Comments on the Feasibility Study
Prepared by Geo-Hydro Inc. on behalf of
People in Need of Environmental Safety
December 26, 2012

Geo-Hydro Inc. (GHI) is submitting the following comments on the Feasibility Study (FS) for the Pines Area of Investigation dated November 2012, on behalf of People In Need of Environmental Safety (PINES). Our general and specific comments on that document are provided below. Additional comments on the radiological characterization of CCBs in the study area provided by Mr. Larry Jensen, a Health Physicist and member of PINES, are provided in the Appendix. The comments identify the most significant technical issues associated with the FS. GHI and Mr. Jensen will address issues with the FS and prior documents with PINES as the Remedial Investigation/Feasibility Study (RI/FS) process continues and concludes, thereby allowing PINES to fulfill its obligations to the public under the TAP.

Comments on

Pines FS_Figures_November 29_2012

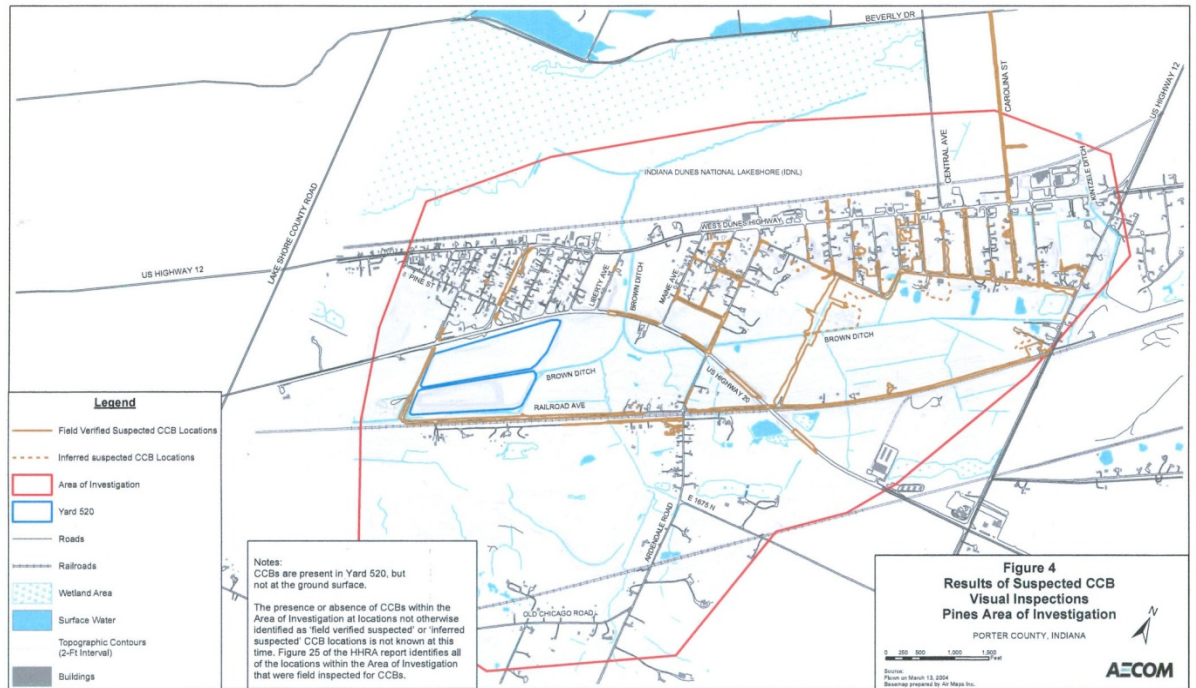
Although Figure 4 (Results of Suspected CCB Visual Inspections) below shows an extensive distribution of CCB throughout the Town of Pines, the sampled areas as shown in Figure 8 (Sample Locations and Results,

No data or maps show surface soil samples were taken in CCB depositions areas as shown in Figure 4.

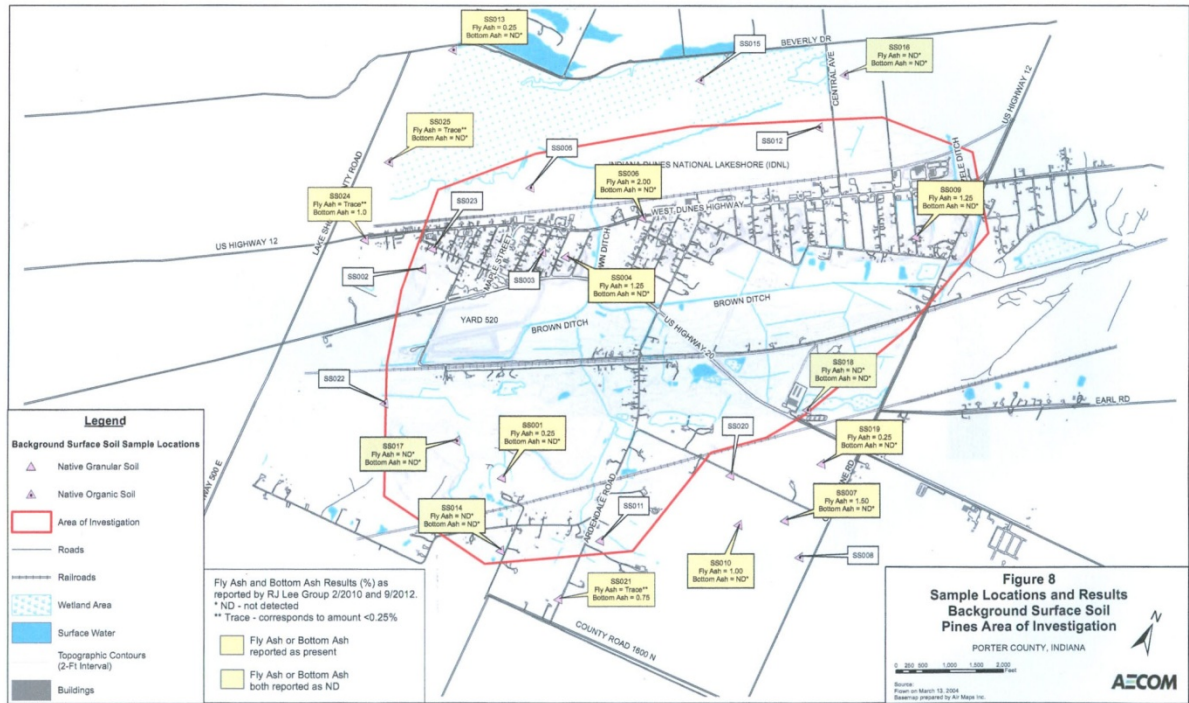
Background Surface Soil) below, with the possible exception of SS009, all appear to be in uncontaminated areas.
